RE: Development Application MCUC 2915/2018, 20 Warner St, Pt Douglas. RFI 18007CL

MICRO HOTEL, 20 WARNER STREET – PORT DOUGLAS
DEVELOPMENT APPLICATION MCUC 2915/2018

RESPONSE TO INFORMATION REQUEST (Council Ref. MCUC
2915/2018(DocID881197) dated 22 Nov.2018 FOR 20 WARNER STREET,
PORT DOUGLAS; LANDSCAPE.

**Re: Development Application MCU for Short-term Accommodation (Hotel)
20 Warner Street, Port Douglas**

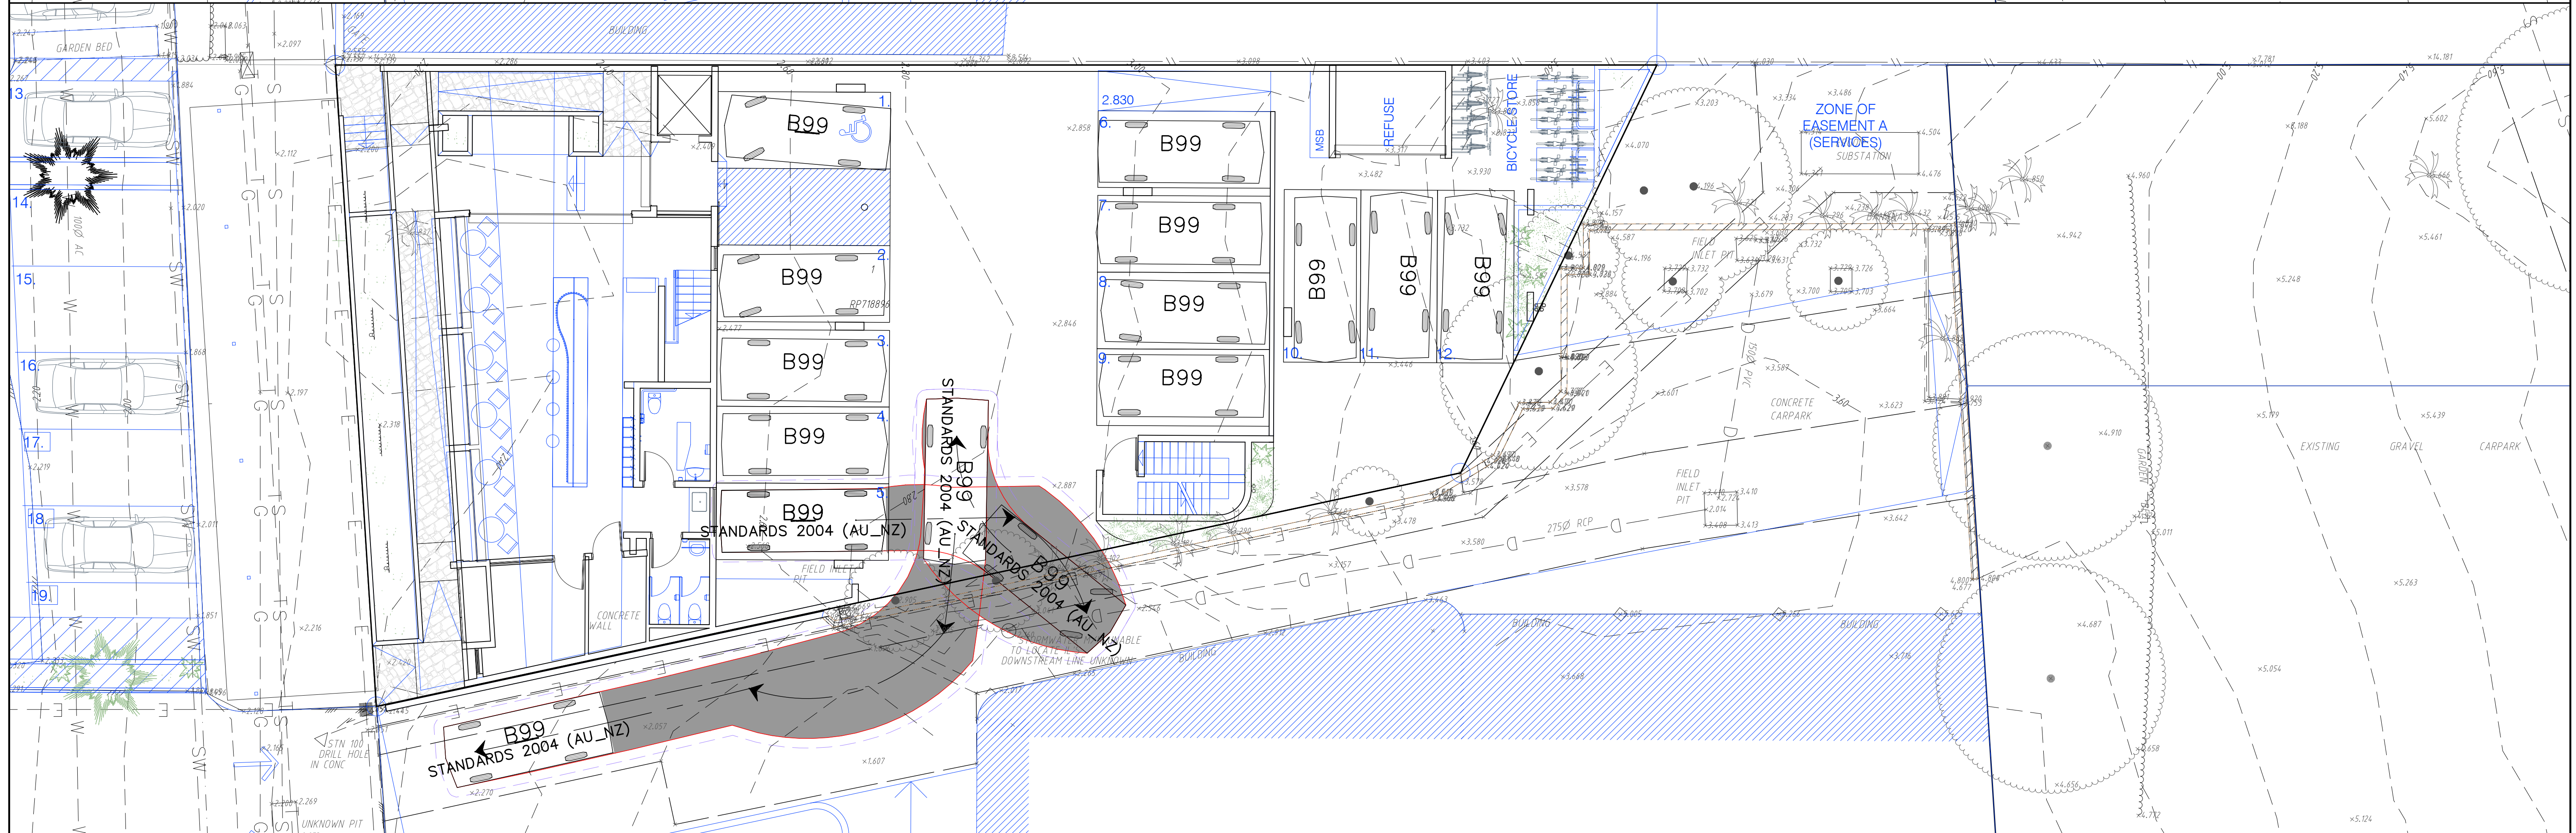
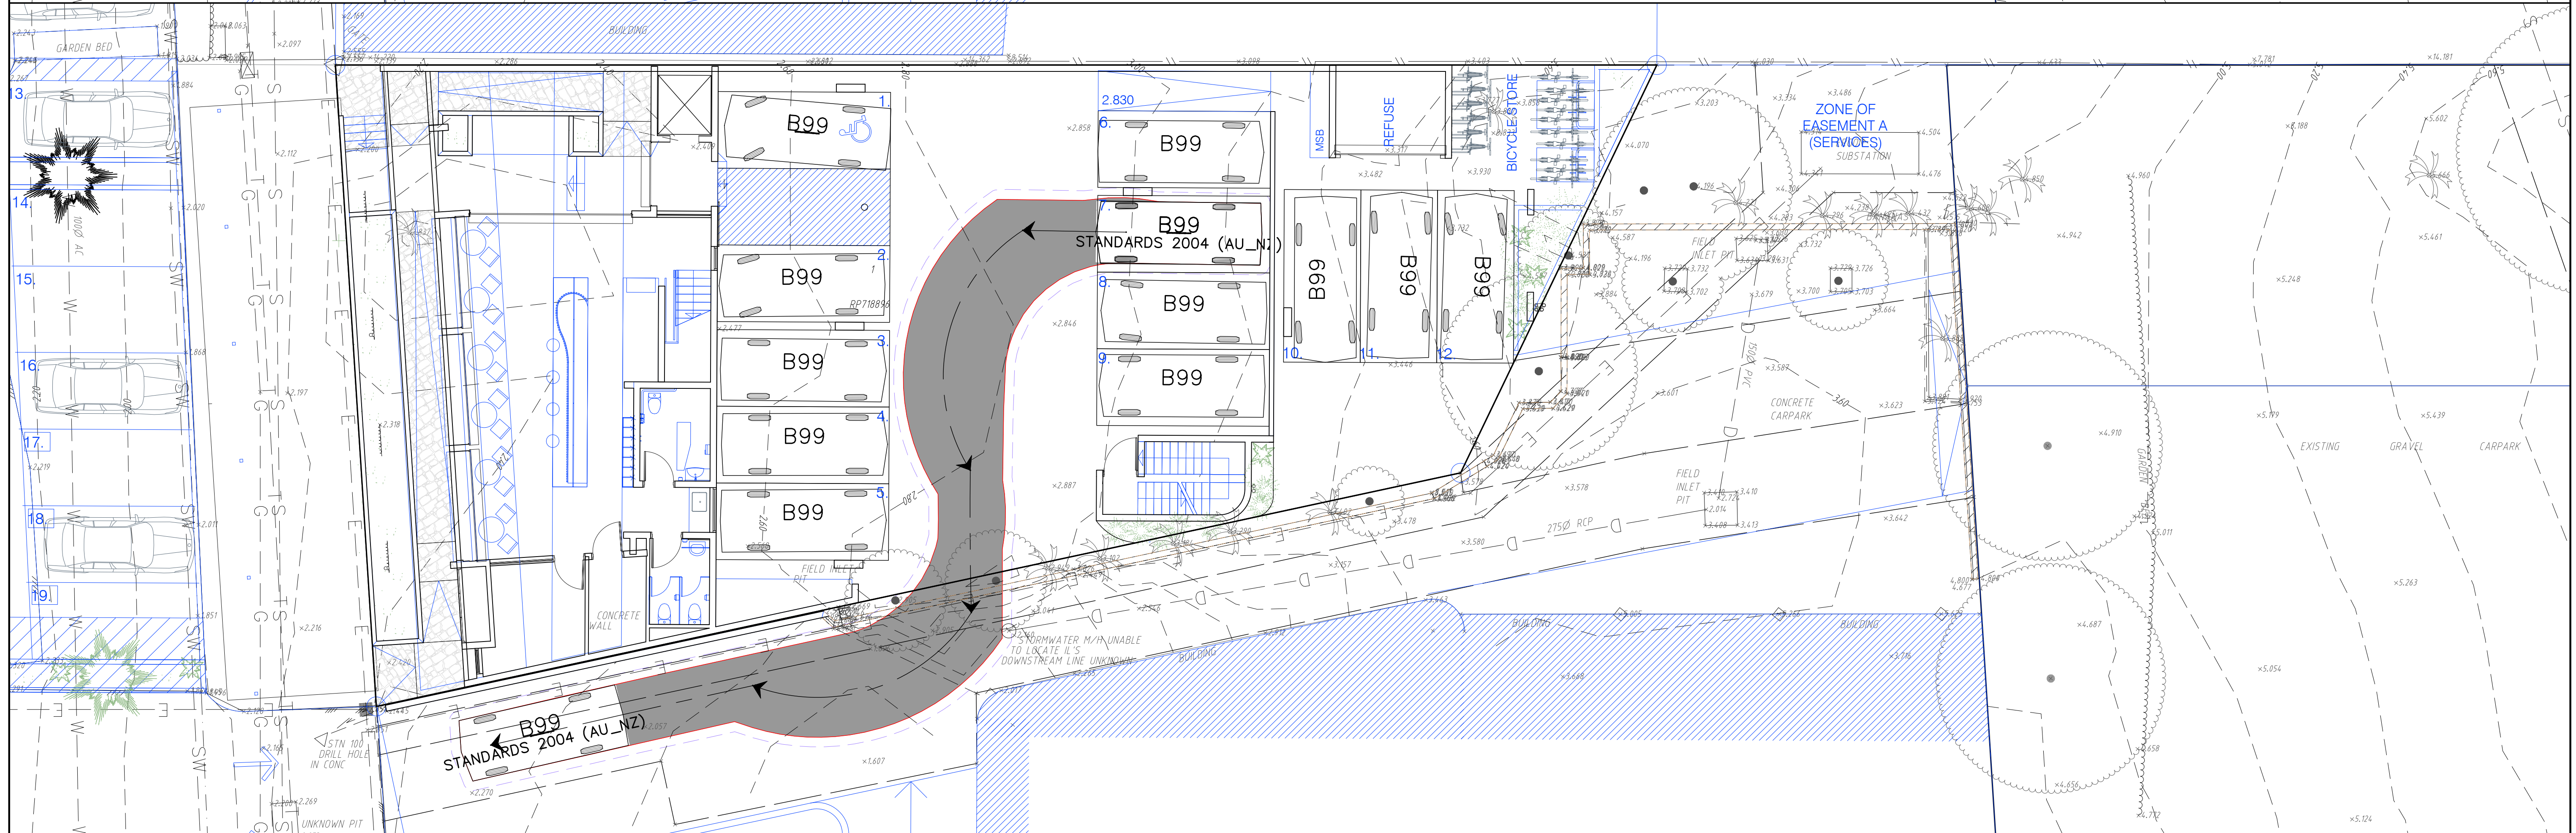
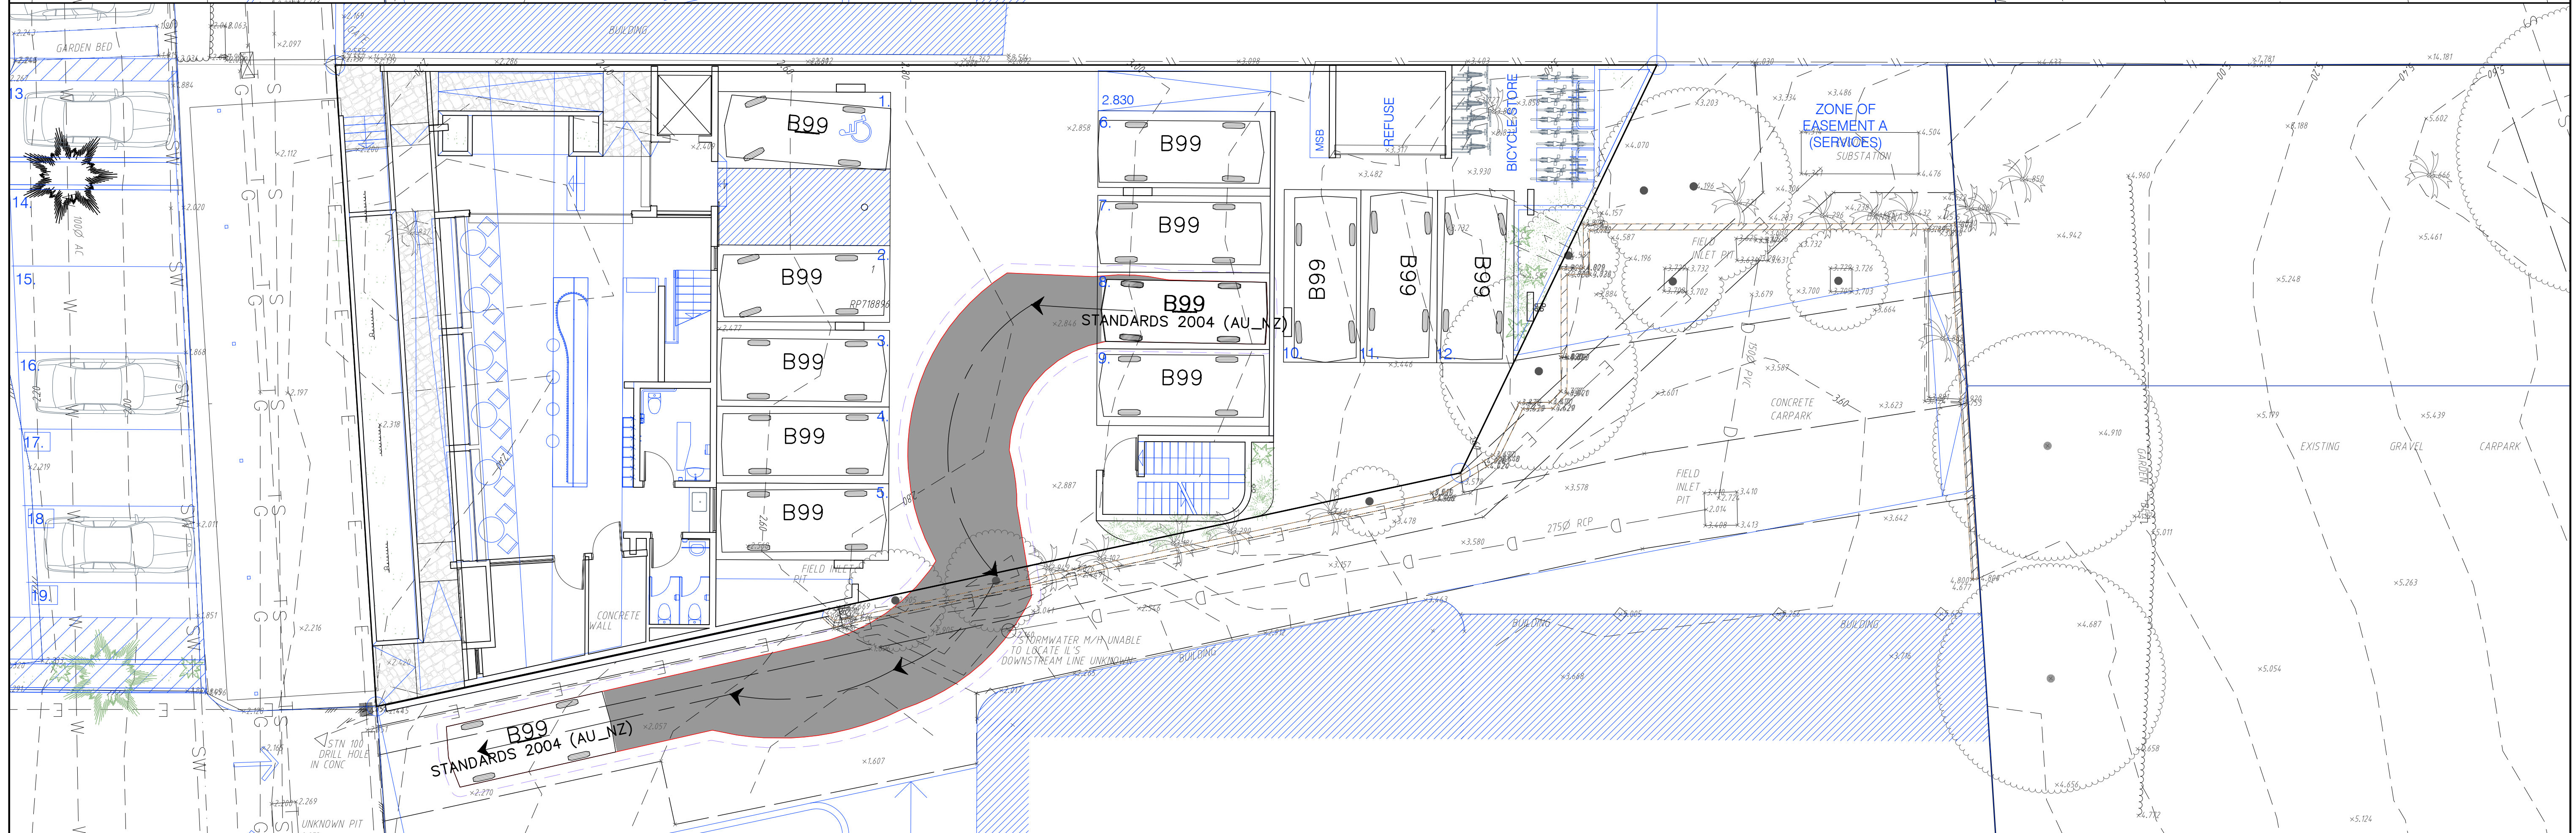
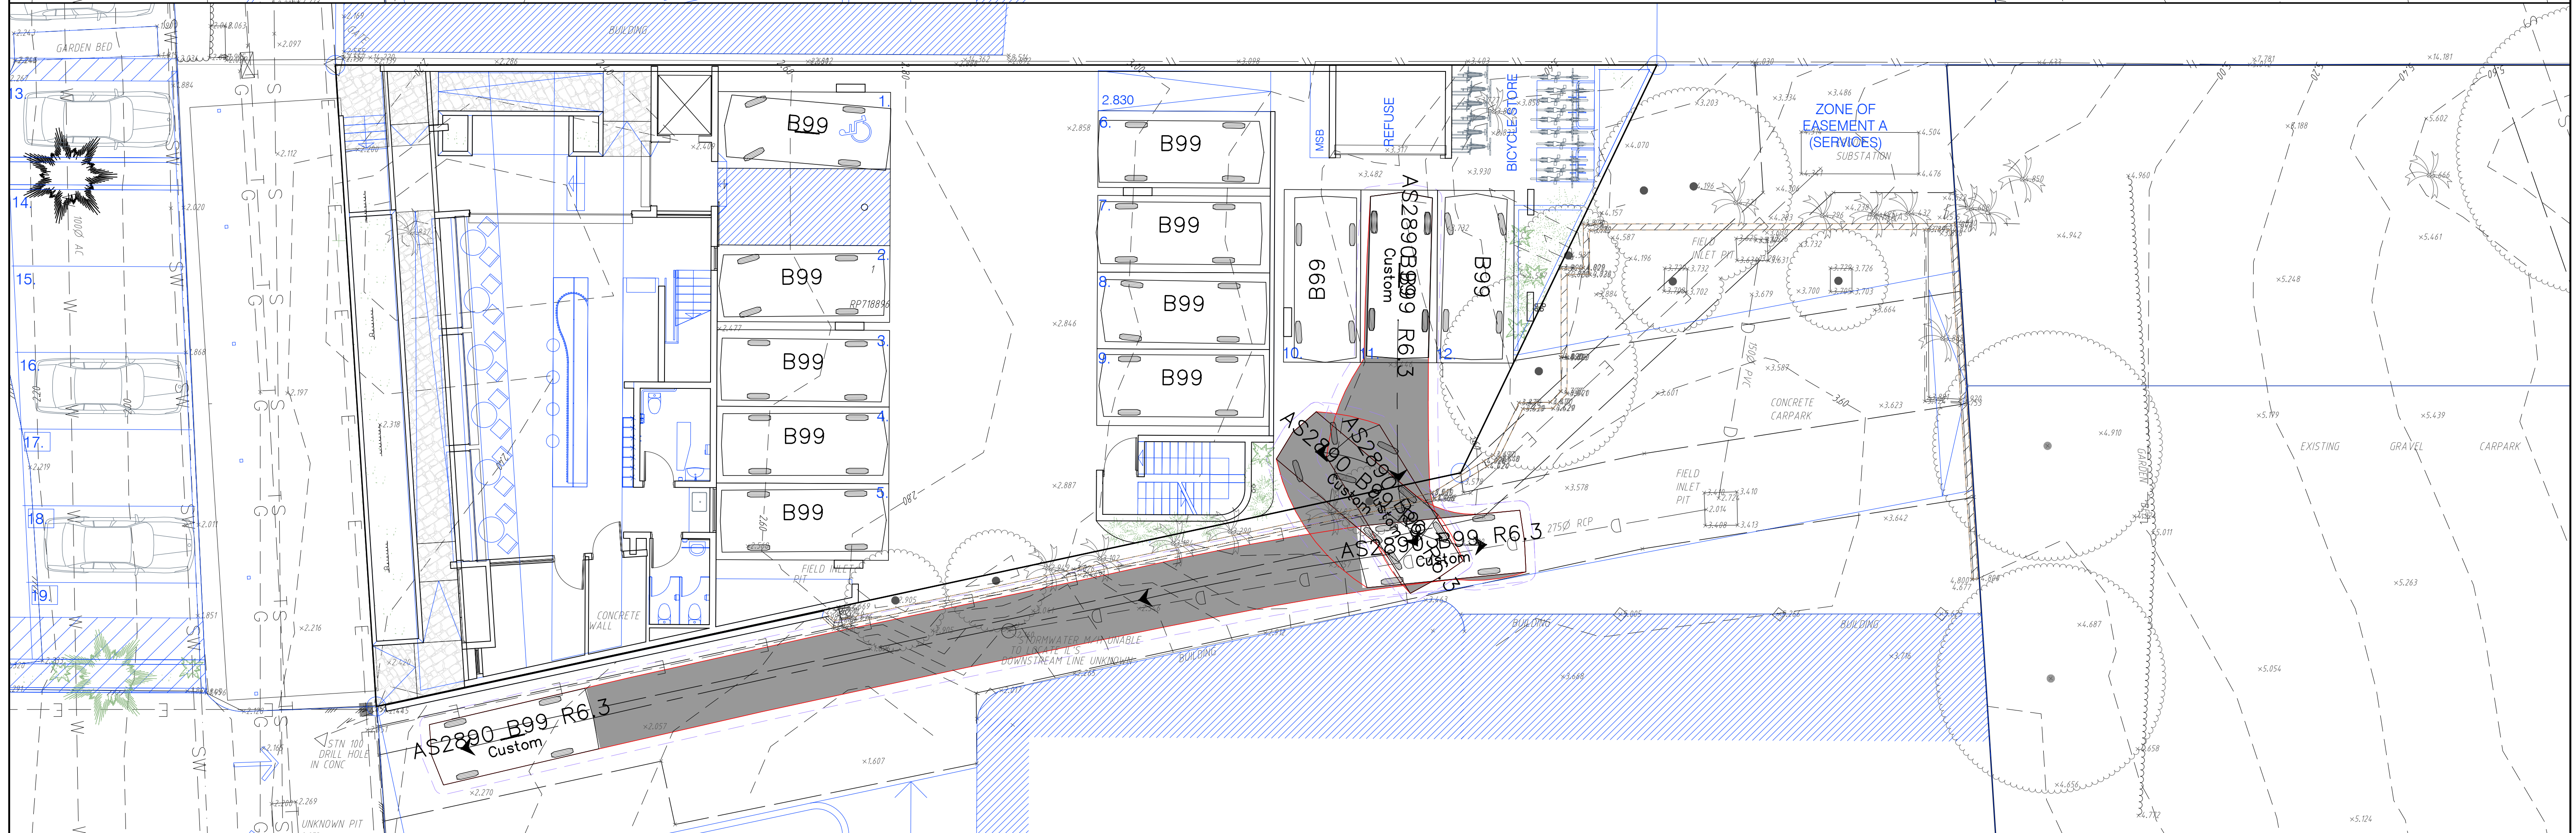
3. On site Vehicle Parking and Traffic Movements a. Please advise of the ability to redesign of the development to achieve a parking design for a B99 vehicle.	a. The consultant traffic engineer has undertaken swept path analysis for a B99 vehicle and concluded that the majority of carparks can accommodate this size vehicle, in accordance with relevant Australian Standards. Refer to Appendix 2.

- Parking spaces 3, 4, 5, 7, 8, 9 & 10 require a B99 design vehicle to reverse into the parking space. Parking spaces 1, 4, 5 & 11 will require three point turns for entry or egress as allowed for in AS2890.1 Table 1.1 for user class 1A parking.

- Parking spaces 1 to 9, 11 and 12 comply with AS2890.1 Figure 5.2 with columns and other obstructions clear of the required parking envelope. Parking space 10 has a column within the parking envelope although it can be demonstrated that the parking space can be accessed by a B99 design vehicle albeit within the 300mm vehicle clearances normally used for swept path design.

- B99 swept paths for entry and egress to each parking space is shown on Rodgers Consulting 180307-SK1 to SK12. Autoturn standard templates were modified for the minimum turning radius allowed for in AS2890.1 Fig B3 & B5.
